BY: Jennifer Fitch DATE: 04/11/2014

Town of Rochester, Vermont. Bridge 19  
ER BRF 0162(18)  
**Traffic Control Plan**

PROJECT NAME: ROCHESTER	PLOT DATE: 3/5/2014
PROJECT NUMBER: ER BRF 0162(18)	DRAWN BY: E.A. FIALA
FILE NAME: zllc332detour.dgn	CHECKED BY: S.E. BURBANK
PROJECT LEADER: S.E. BURBANK	SHEET 2 OF 3
DESIGNED BY: E.A. FIALA	
BR 19 TRAFFIC CONTROL PLANS (1 OF 3)

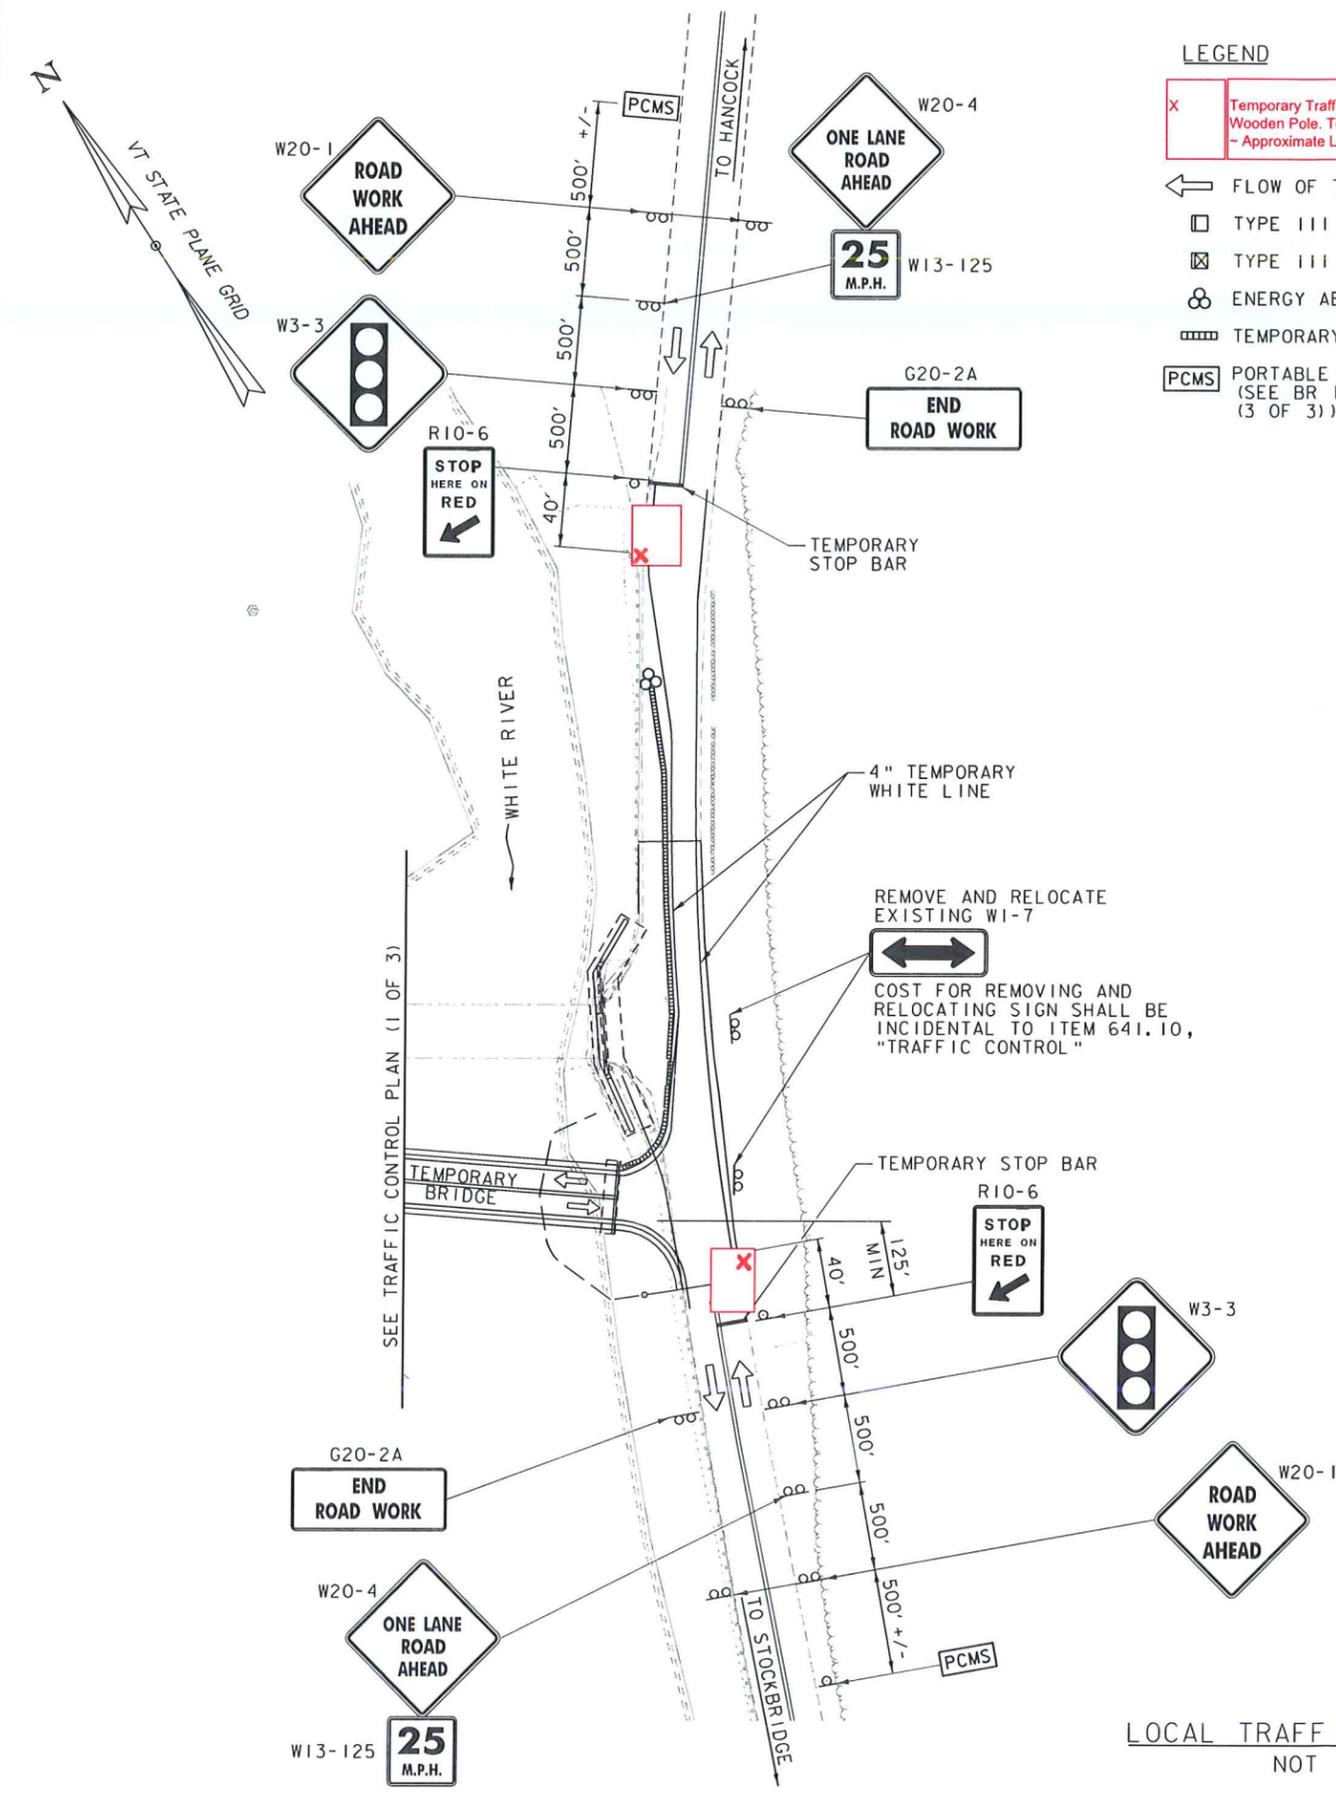
- (1) Date the cover letters on your future submittals.
- (2) Define the acronym "MP&T" as this is not one used by the State of Vermont
- (3) There shouldn't be any "permanent" road closures. Replace permanent with temporary.
- (4) The contractor will need to make sure that all legal road users are able to maneuver through the lane closures including TT-units. A minimum 14 ft lane is required for single lane roadways. More may be needed due to intersection geometrics and off-tracing of large trucks
